From: Joe Jursenas <jjursenas@briohn.com>
Sent: Wednesday, July 7, 2021 1:17 PM
To: Hanson, David L - DNR
Cc: Morgan Jursenas; Jursenas Joseph; Kate Juno
Subject: RE: DNR Post Closure Modification Request for the Former Quick Cleaners, 530 Franklin St, Oconomowoc, BRRTS #02-68-280310
Attachments: 530 Franklin St - Floor Plan.pdf; 530 Franklin Street PDF.pdf; Post Closure Workplan 530 Franklin Oconomowoc.pdf

From: Hanson, David L - DNR <David.Hanson@wisconsin.gov>
Sent: Thursday, June 3, 2021 8:54 AM
To: Kate Juno <katejuno@lfgreendevlopment.com>; Ifellenz lfgreendevlopment.com <lfellenz@lfgreendevlopment.com>
Cc: Hanson, David L - DNR <David.Hanson@wisconsin.gov>
Subject: DNR Post Closure Modification Request for the Former Quick Cleaners, 530 Franklin St, Oconomowoc, BRRTS #02-68-280310

Proposal for Sub-Slab Communication Testing at 530 Franklin Street in Oconomowoc WI

530 FRANKLIN ST, OAKENHAW, WI 53066

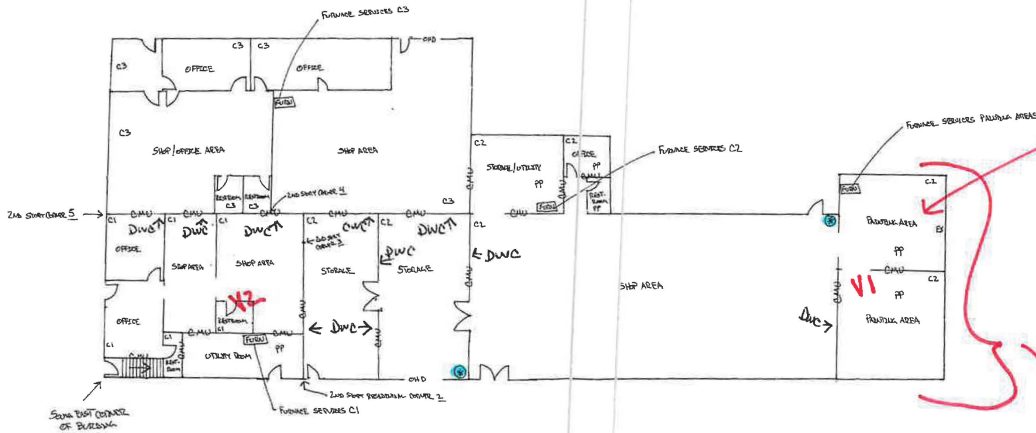
2. Prior to sampling, the building needs to be evaluated. Submit a figure showing the building interior layout and features; the location of the former drycleaning equipment, and; the proposed indoor air sampling and pressure field extension (PFE) testing locations. Include a discussion explaining why the indoor air and PFE testing locations were chosen.

3. All VOC containing chemicals should be removed from the building prior to indoor air sampling.
4. Collect Indoor air samples in both residential units, ideally in the bathrooms.

- a. Response: The attached detailed drawing shows the building interior layout, including the location of the former dry-cleaning equipment, and; the proposed indoor air sampling locations. As identified in Lifetime's proposal, the pressure field extension (PFE) testing locations will be placed in an approximate 5-15 foot grid pattern going out from the location of the existing mitigation systems. We also understand that PFE locations must be placed a minimum of 5 feet from any exterior wall.

4. Collect Indoor air samples in both residential units, ideally in the bathrooms.
 - a. Response: We will collect Indoor air samples in the bathrooms of both residential units.

→ EXISTING TENANT PAINTING AREA. ALL VOC PRODUCTS CAN NOT BE REASONABLY REMOVED WITHIN THIS AREA.
